Service Bulletin

VTX1800C/R #2
DECEMBER 2004

SAFETY RECALL

2002 VTX1800C/R Side Stand Spring Hook Bolt Failure

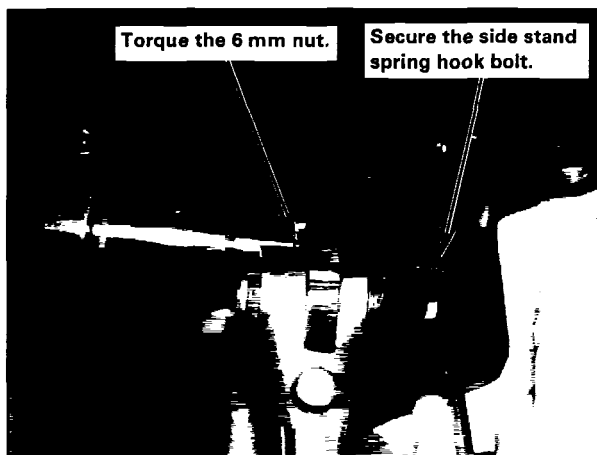
The washer for the side stand spring bolt does not have sufficient hardness and may deform, which could cause the bolt to flex and eventually break during side stand operation. In limited circumstances, a retracted side stand could drop while riding, possibly activating the side stand ignition cut-off system. If the ignition is cut, the engine will stall without warning, which could cause a crash.

8. Wearing eye protection, remove the side stand springs using an appropriate tool.
9. Remove the 6 mm nut and then the side stand spring hook bolt and washer. Discard the nut, bolt, and washer.
10. Install the new side stand spring hook bolt and washer and tighten. It is very important that you **completely seat** the hook bolt against the washer and side stand bracket, and tighten to the specified torque.

Torque: 10 N·m (1 kgf-m, 7 lbf-ft)

11. Install the new 6 mm nut and while **securely holding the hook bolt**, tighten.

Torque: 12 N·m (1.2 kgf-m, 9 lbf-ft)

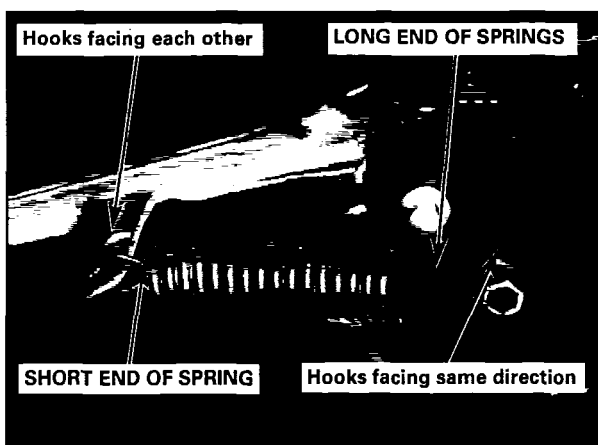
12. Wearing eye protection, reinstall the springs using an appropriate tool, making sure to orient the springs correctly. The long-ends of both springs should be attached to the hook bolt with their hooks facing in the same direction. The short-ends of the springs should be attached to the side stand with their hooks facing each other.

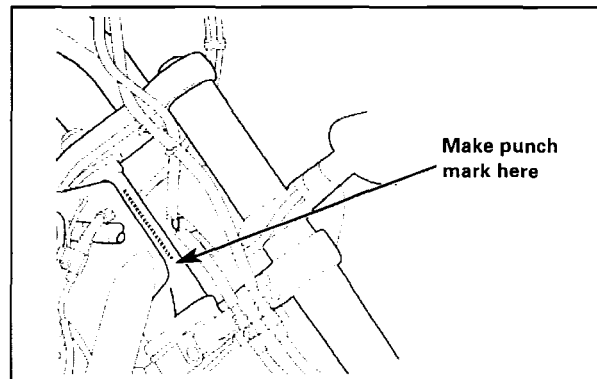
13. Lubricate the side stand pivot with a lithium based multi-purpose grease.
14. Reinstall the side stand mounting bracket to the frame with the three 10 mm bolts and tighten them.

Torque: 39 N·m (4 kgf·m, 29 lbf·ft)
